WBGXC2601001

New assembly plant for Littelfuse high voltage MOSFET in i4 package

Littelfuse intends to transfer the assembly of its high-voltage MOSFET in isolated ISOPLUS i4pac packages into its in-house assembly facility in the Philippines soon. This transfer will improve our supply chain efficiency, and our service levels for customers.

Bill of Material changes

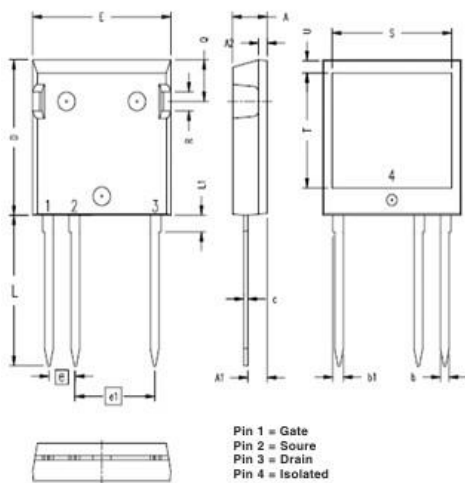
ASSEMBLY COMPONENT	Change
Die	No
DCB	No
Lead frame	No
Solder Material	No
Wire	No
Molding Compound	No
Pin plating material	Yes (new: pure tin)

New location – example part marking

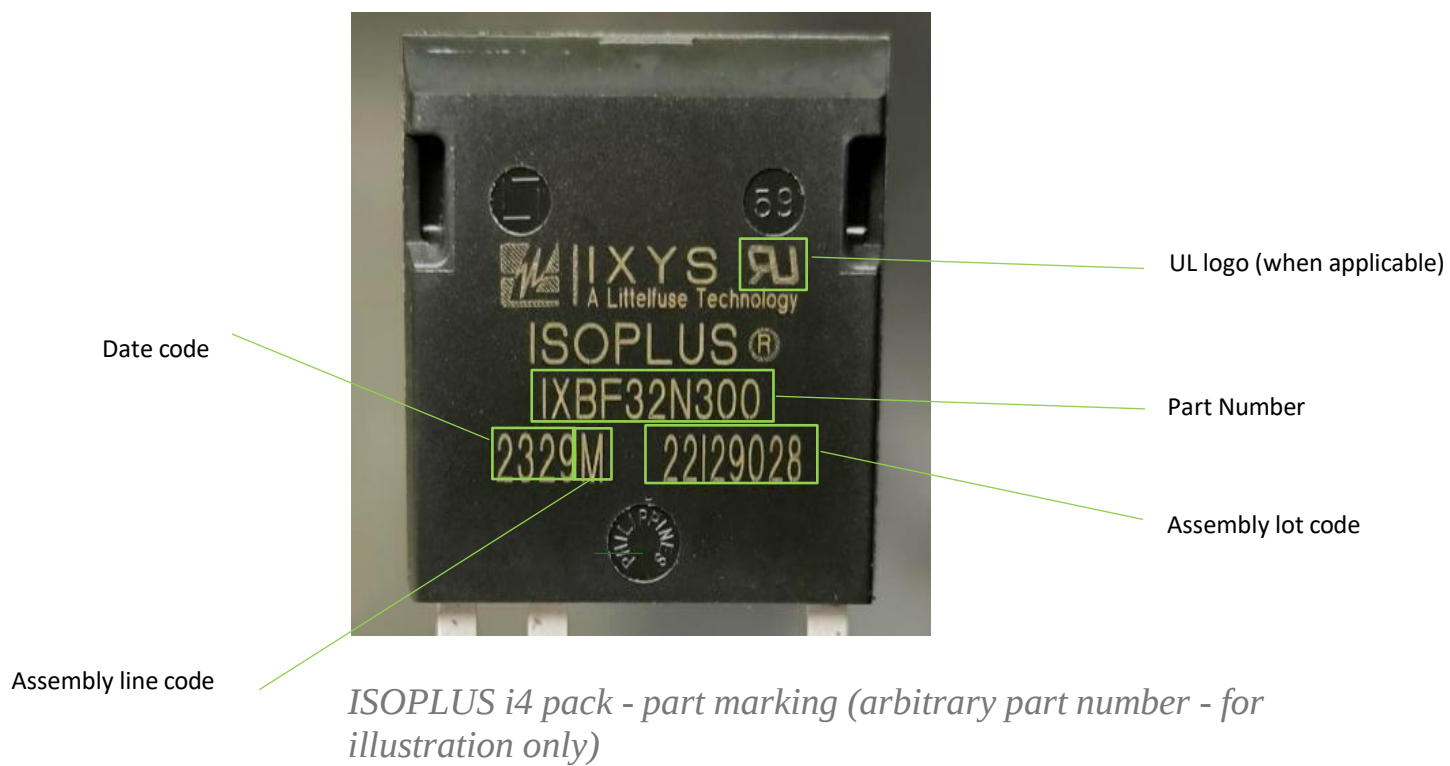
Description	Existing location	New location	Change
Unit Marking			
Logo			Y
UL Logo	No UL Logo	With UL Logo	Y
Isoplus Trademark	None	With trademark	Y
Partname	Device Name	Device Name	N
Date Code	FPMDDYY	YYWW	Y
Assembly line code	P	M	Y
Lot #	Fab lot ID	Lipa Lot #	Y
Tube Label			
Logo			Y
Qty per tube	25	25	N
Part Number	Device Name	Device Name	N
Lot No	Fab Lot ID	Lipa Lot ID format	Y
Country of Origin	Yes	Yes	N
Code Type	Barcode	Barcode + 2D Code	Y
Date Code	None	YYWW	Y
Assembly line code	None	M	Y
Box Label			
RoHS Label			Y
Logo			Y
Qty per Box	250	250	N
Part Number	Device Name	Device Name	N
Lot No	Fab Lot ID	Lipa Lot ID format	Y
Country of Origin	Yes	Yes	N
Code Type	1DBarcode	1Barcode + 2D Code	Y
Date Code	None	YYWW	Y
Assembly line code	None	M	Y
